Access Compliance Report

Public Rights-of-Way

(Curb Ramps)

Intersection ID: 6198	Main Street: FAIRES_FARM_RD	Cross Street: JEFFREY_BRYAN_DR	Location: S
ADA ID: CE21F8E2C7E0	Ramp Type: PerpDiag	Initial Pass/Fail: Fail	Overall Compliance: No
Severity Score: 8.75			
Codes/Mitigation Info/Possible Solution		Field Measurements/Component Compliance

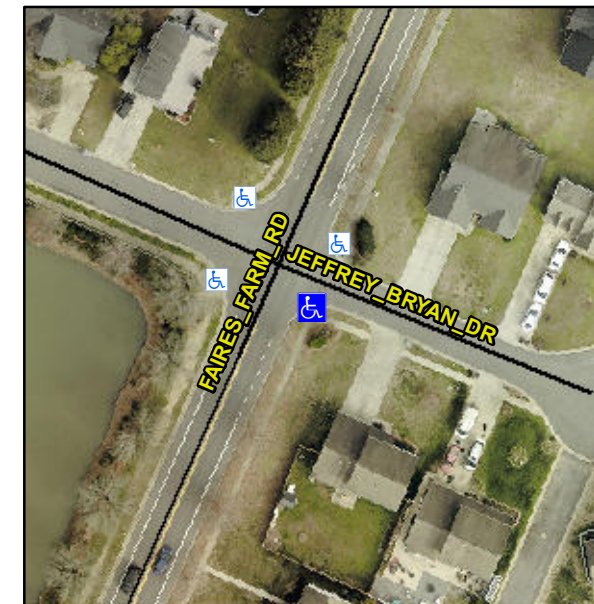
R304.5.1

Compliance	Description	Data	Compliance	Description	Data
N/A	Ramp Length (in)	49.0	Yes	Ramp Slope (%)	5.6
No	Ramp Width (in)	42.0	Yes	Ramp XSlope (%)	0.6
N/A	Flare Type LT	N/A	N/A	Flare Type RT	N/A
N/A	Flare Slope LT (%)	N/A	N/A	Flare Slope RT (%)	N/A
N/A	Flare Traversable LT?	N/A	N/A	Flare Traversable RT?	N/A
N/A	Landing Length (in)	N/A	N/A	DWS Provided?	N/A
N/A	Landing Width (in)	N/A	N/A	DWS Contrast?	N/A
N/A	Landing Slope (%)	N/A	N/A	DWS Length (in)	N/A
N/A	Landing X Slope (%)	N/A	N/A	DWS Full Width?	N/A
N/A	Landing Curb? (Y/N)	N/A	N/A	DWS Offset (in)	N/A
N/A	Shared Landing?	N/A			
N/A	Gutter Ponding?	N/A	N/A	Gutter Slope (%)	N/A
N/A	Gutter Lip Ht (in)	N/A	N/A	Gutter X Slope (%)	N/A
N/A	Painted X Walk1?	No	N/A	Painted X Walk2?	No
	X Walk 1 Direction	To E		X Walk 2 Direction	To W
N/A	X Walk 1 Width (in)	N/A	N/A	X Walk 2 Width (in)	N/A
	X Walk 1 Slope (%)	2.5		X Walk 2 Slope (%)	2.1
	X Walk 1 X Slope (%)	3.3		X Walk 2 X Slope (%)	0.4

Remove & Replace Curb Ramp With Two New Directional Ramps or Equivalent.
